REMARKS

FIG. 2

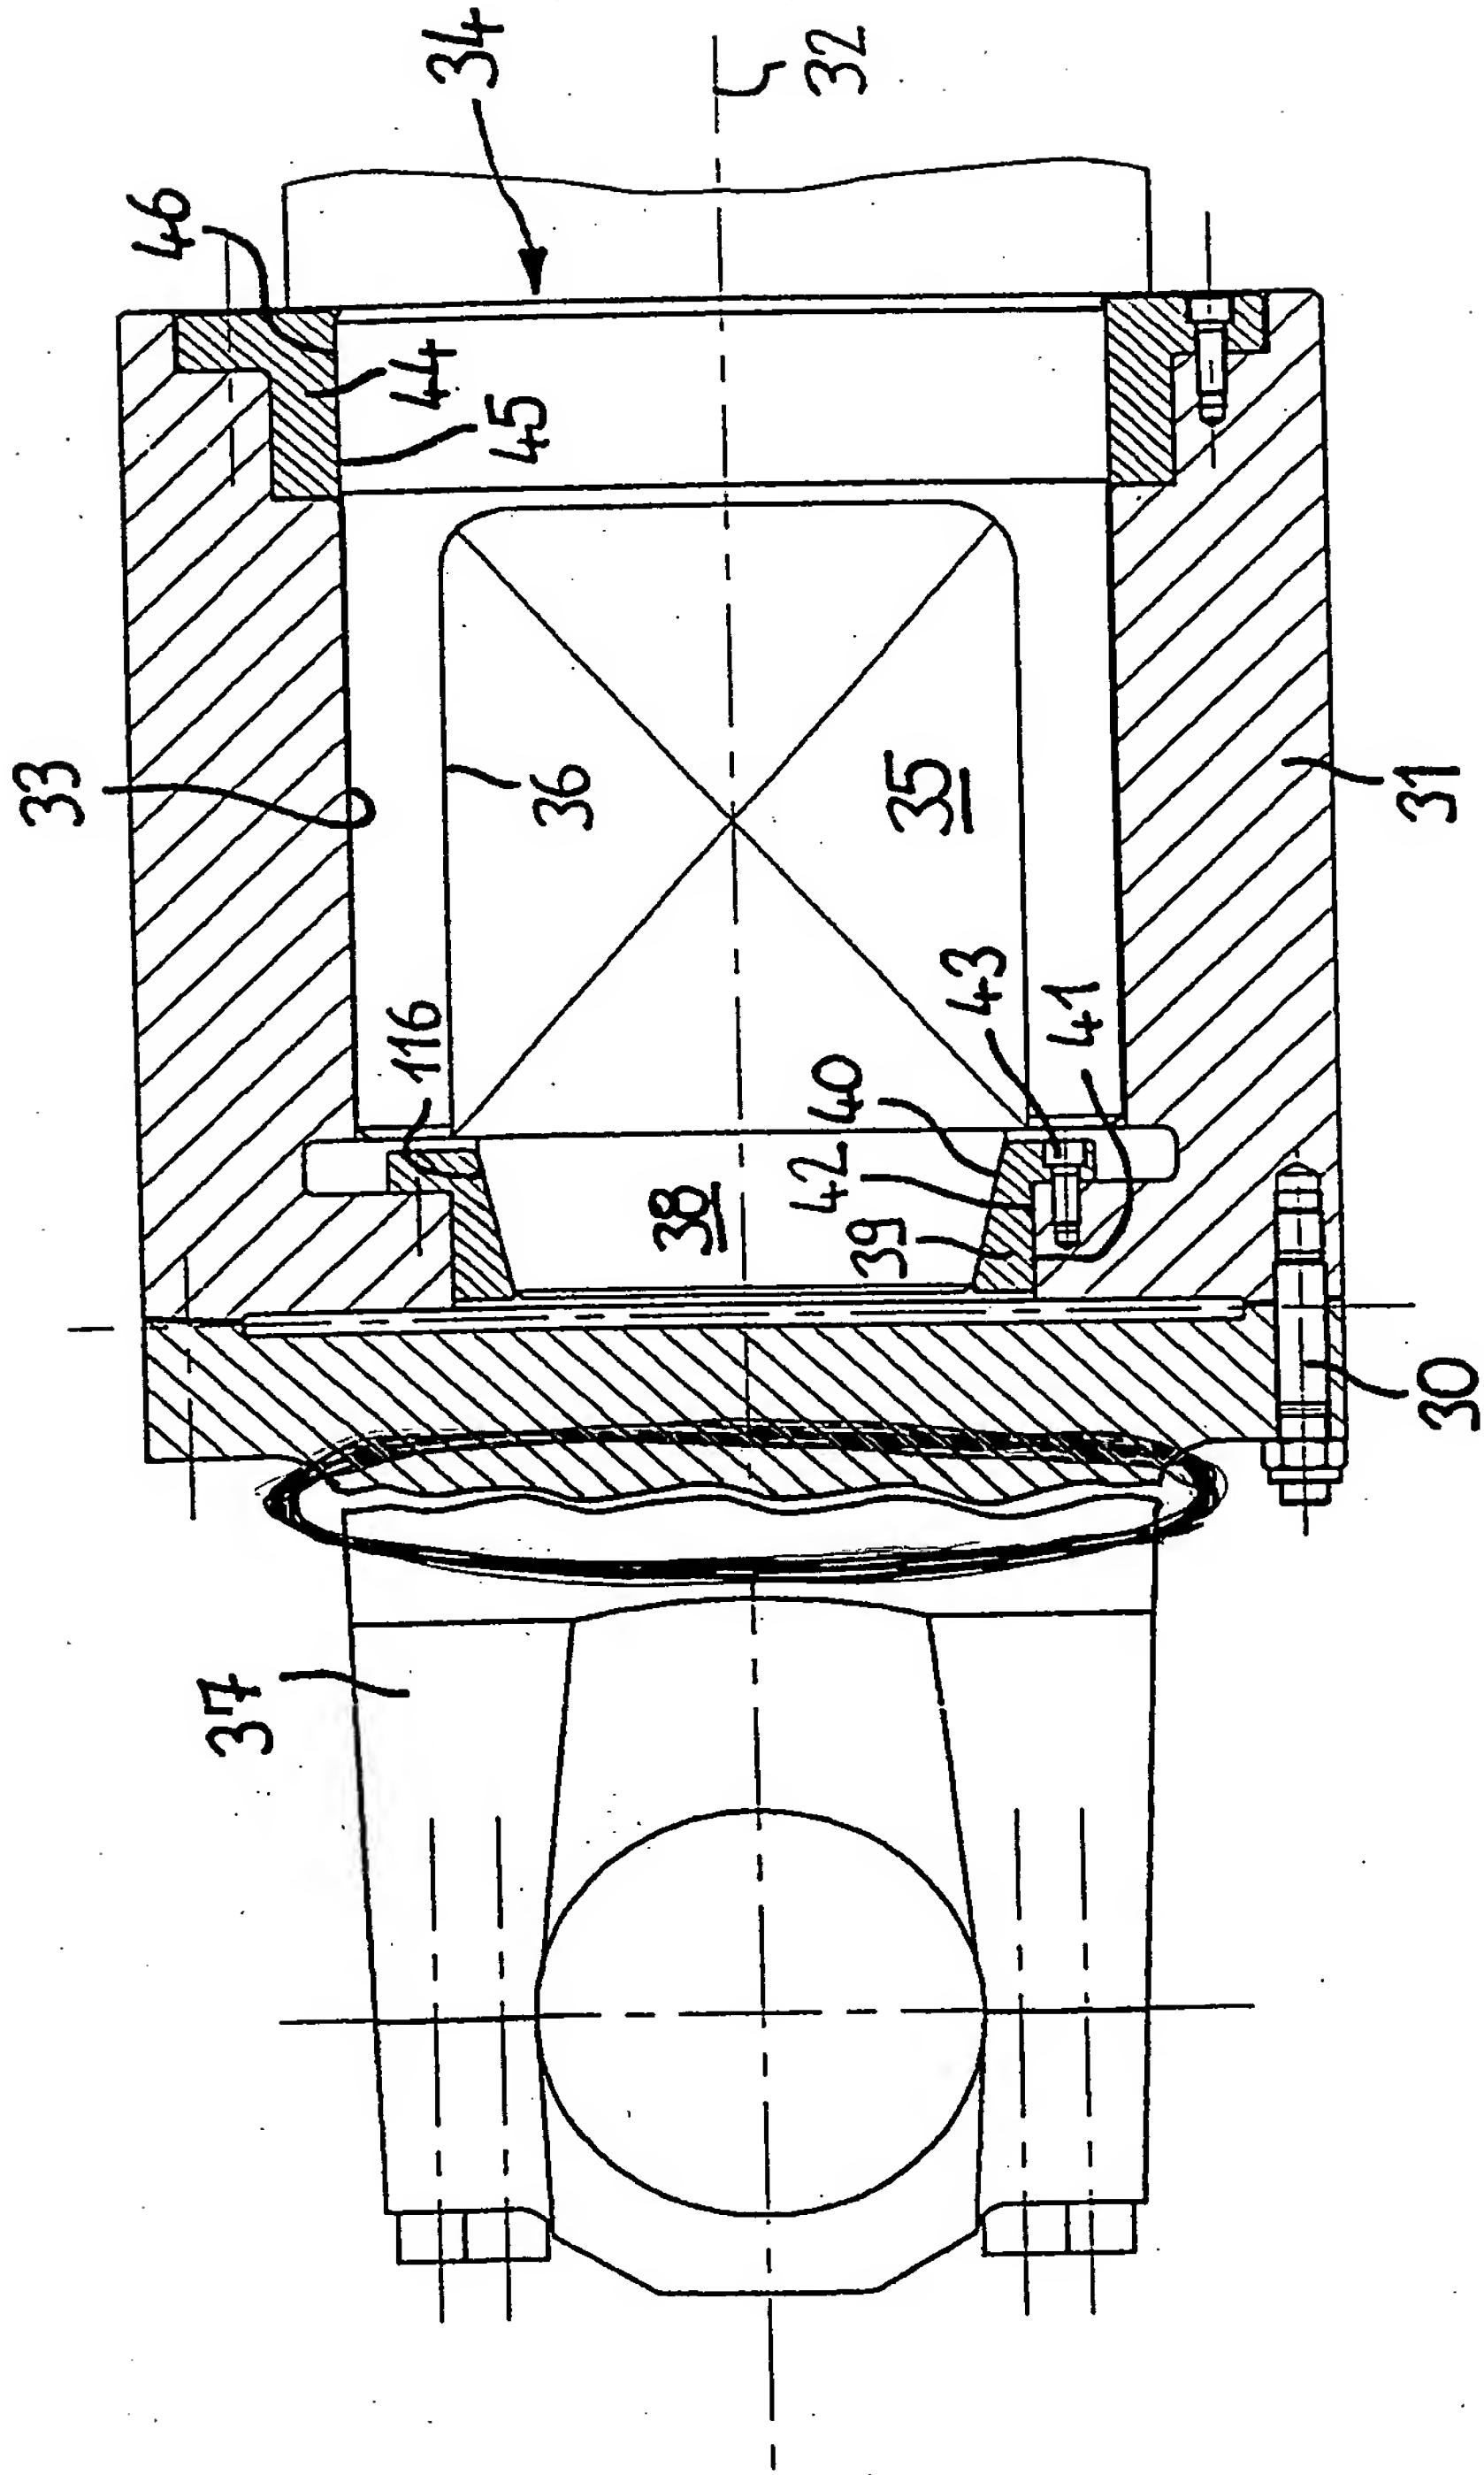
The Examiner also objected to the drawings because of an inconsistency between Figs. 1 and 2. Fig. 2 is proposed to be amended as shown in the attached photocopy to address this. Formal drawings including this proposed revision are also enclosed.

The Examiner further objected to the drawings because the lead line for numeral 116 in Fig. 2 appeared to point to two different features. In Fig. 2, the lead line for numeral 116 does not split. However, it does pass near a phantom line that illustrates the radial position of the fasteners 43 used to secure the 39 centering ring to the coupling sleeve 31. In the enclosed formal drawings, this distinction is more clearly illustrated. Thus, revision of the drawings in this regard is not believed to be necessary.

Lastly, the Examiner objected to the drawings because certain features were not believed to be shown. This objection is respectfully traversed. Fig. 2 does, in fact, show two the “transmitting faces for transmitting torque” for the coupling sleeve - one is shown at the end of lead line for numeral 33, and the other is shown at the corresponding location at the bottom of the receiving bore. Also, Fig. 2 does, in fact, show the “cylindrical bore that is provided in the region of the aperture” at the end of lead line 45. The applicant agrees with the Examiner that additional views would more clearly illustrate these structures. However, it is believed that the existing drawings adequately illustrate these features of the invention.
